Planning Commission Agenda Report

Files: S/PD 05-15

RE: Modification of Phase IV and V of the Wildwood Estates Subdivision and Planned Development Permit (S/PDP 05-15)

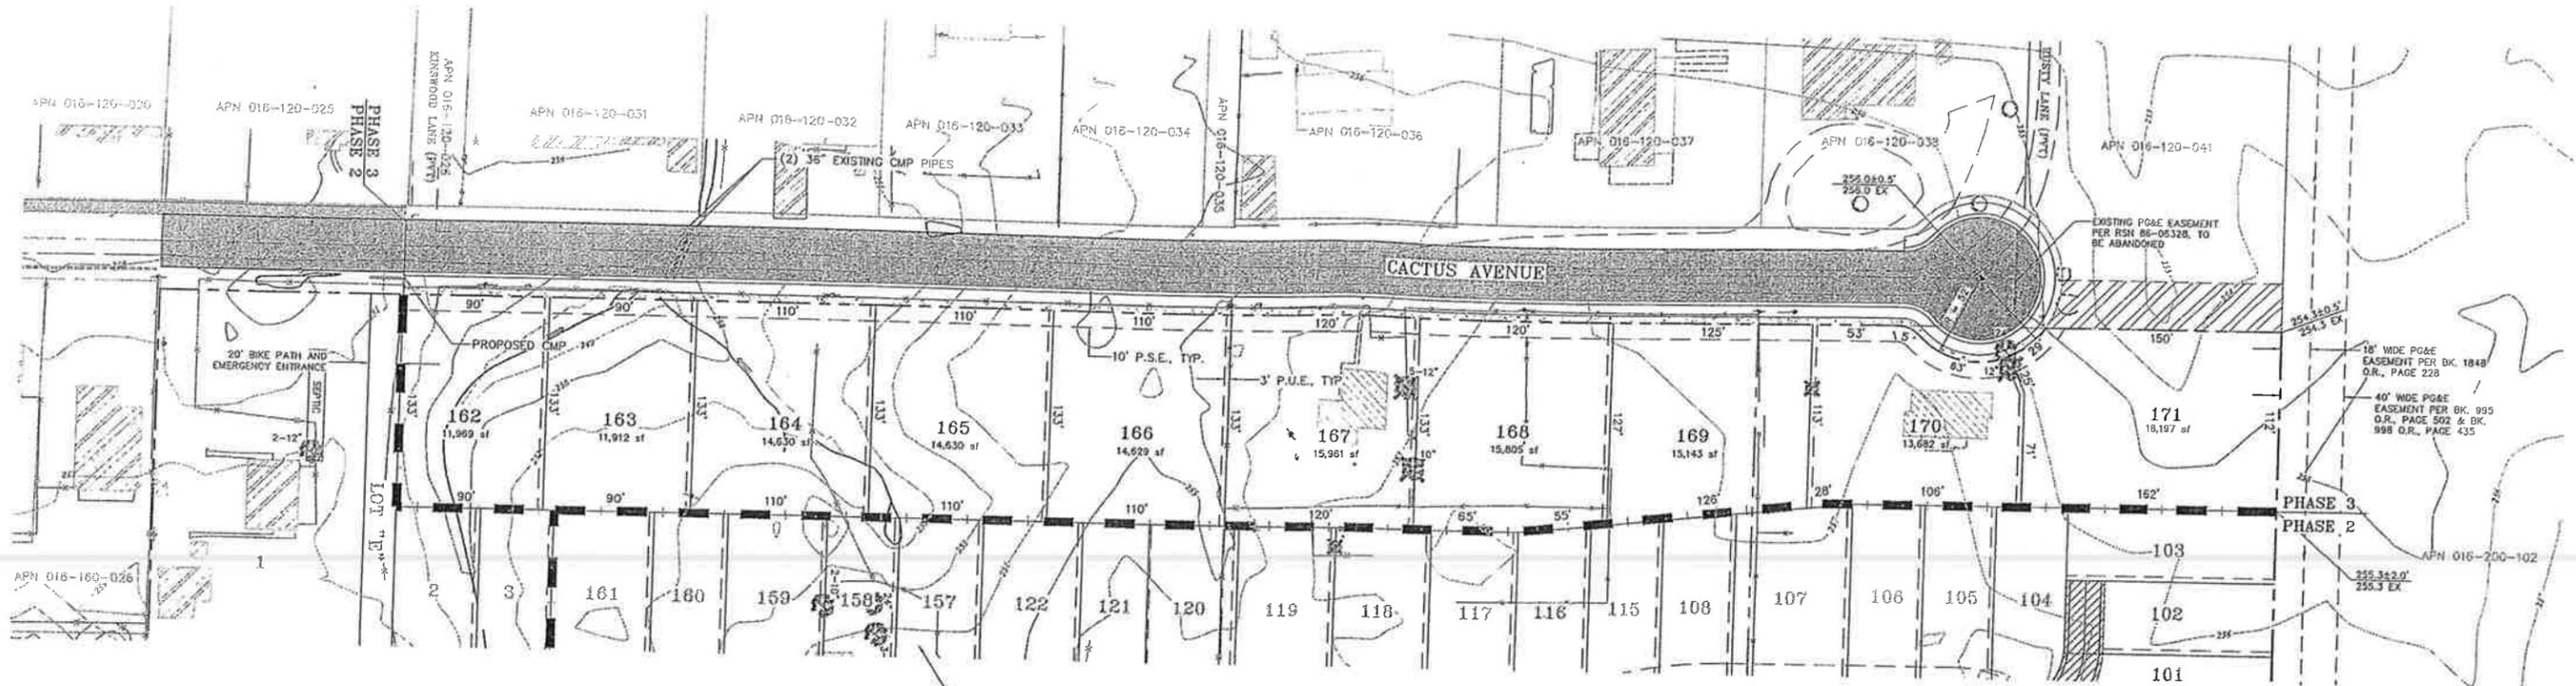
2. Revise the subdivision design to include an additional residential lot fronting onto Cactus Avenue.

The approved subdivision map shows 10 single family homes fronting onto Cactus Avenue (see Approved 2006 Cactus Avenue Map, **Attachment 5**). The lot sizes range from 11,912 to 18,197 square feet, the SD-7 Overlay zoning district requirements that lots fronting Cactus Avenue be a minimum of 10,000 square feet (see Chico Municipal Code Section 19.52.070.D.7, **Attachment 6**).

The introduction of a single lot would not have an adverse impact upon residents, in that the development potential for Cactus Avenue is limited due to the overlay zoning requirement of minimum lot sizes (See Proposed Modified Cactus Avenue Map, **Attachment 7**). Further, the addition of one lot to the overall project site will partially offset the reduction in lots as requested

3. Subdivision design for lots fronting onto Cactus Avenue shall be modified to permit an 11th lot that meets the SD-7 – Special Design Considerations Overlay requirements found in Chico Municipal Code Section 19.52.070.D.7 as shown in Attachment 7 of the March 17, 2016 Planning Commission Staff Report.

LAYOUT APPROVED IN 2006

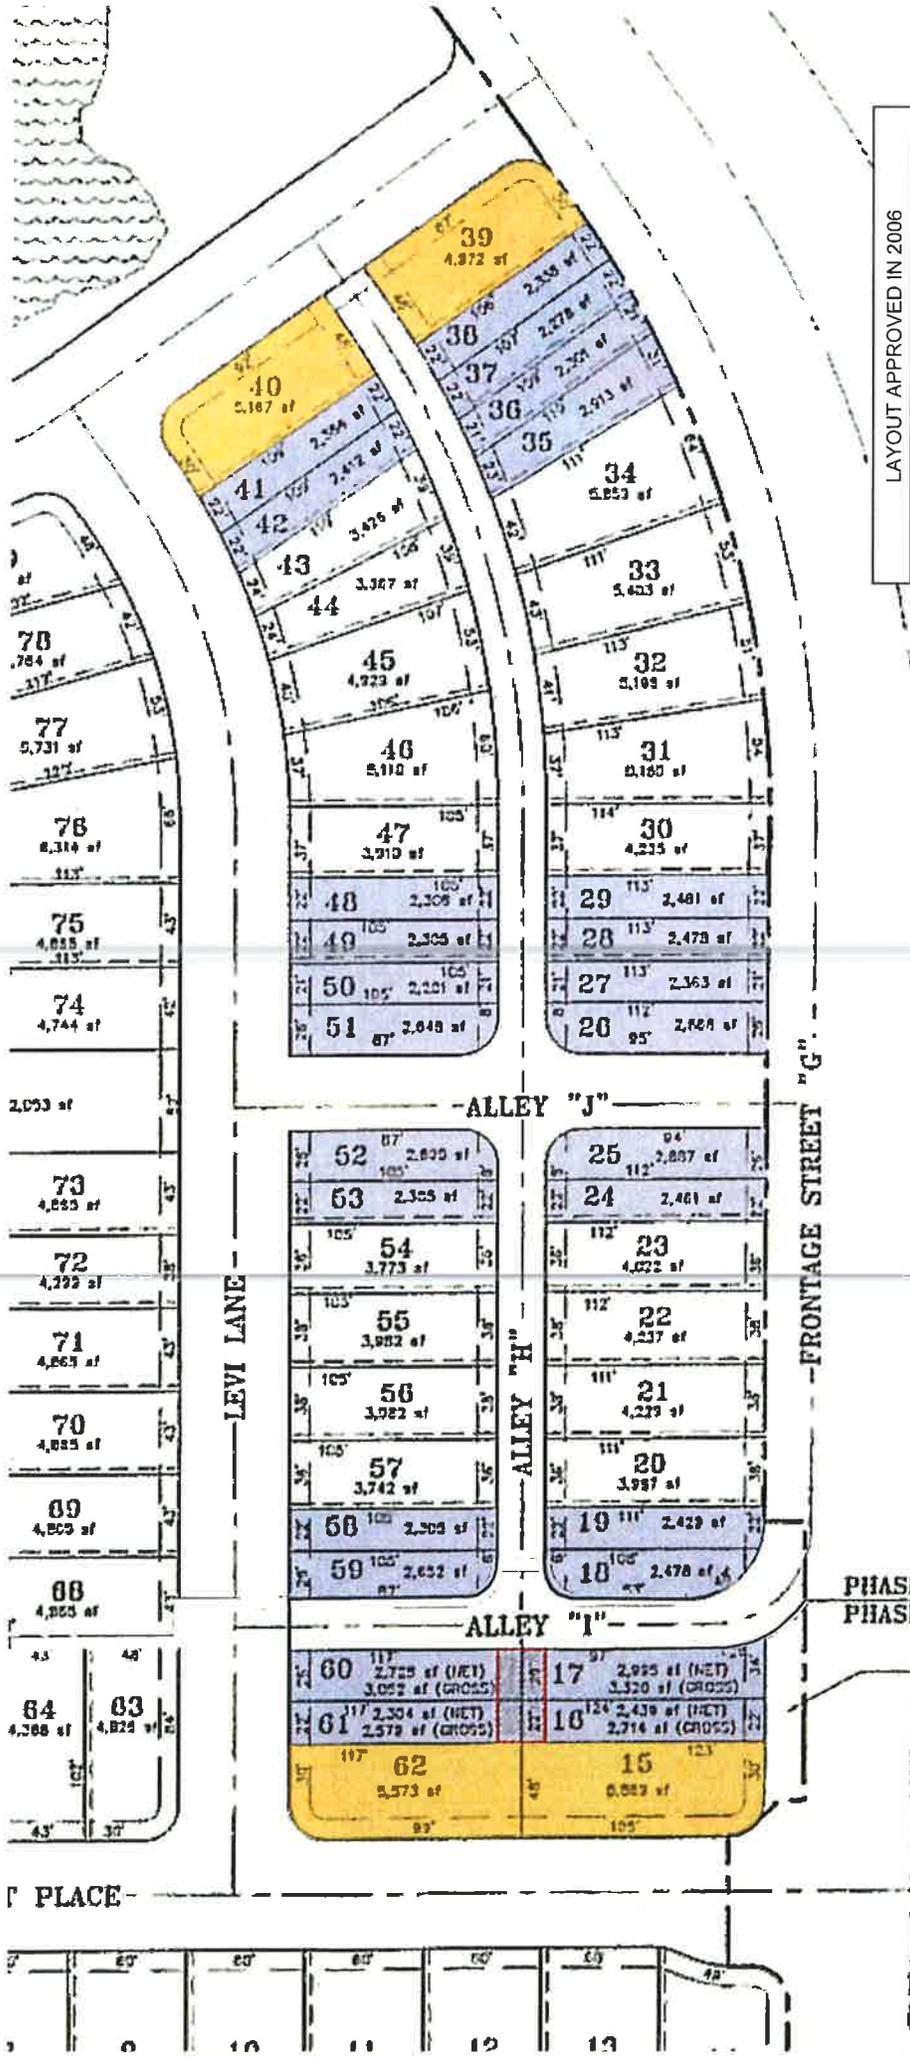
The approved subdivision map indicated a total of 20 “duet” lots, which are a duplex product, under individual ownership (see Approved Levi Lane Map, **Attachment 8**). Part of the request is to reduce from 20 duets to 4. To allow single family home lots in their place (see Proposed Modified Levi Lane Map, **Attachment 9**).

The second portion of the request is to change the lot layout and unit types along Pendant Place. The approved map includes two duplex structures and four duets at this intersection. The request is to provide a row of townhomes (see Townhome Elevations, **Attachment 10**). Because the subdivision is a Planned Development, deviations and modifications from standards are allowed, and structural review by the Architectural Review and Historic Preservation Board required prior to issuance of building permits. Therefore a condition of approval, noting this requirement has been placed on Exhibit I.

The third modification request in the Levi Lane area is to delete Lot “B,” an area of open space at the intersection of Pendant Place and Eaton Road. Upon review of the record, staff is unable to determine why Lot “B” exists. It appears that Lot “B” would be an open area that would be a part of a maintenance district the city would be required to upkeep and maintain.

4. Subdivision design for lots within the "Levi Lane" portion of the subdivision shall be modified to allow the removal of 20 "duet" lots and permit 4 "duet" lots as shown in Attachment 8 of the March 17, 2016 Planning Commission Staff Report.

6. Lot "B" on Tentative Subdivision Map Date Stamped 12/13/06 shall be deleted.
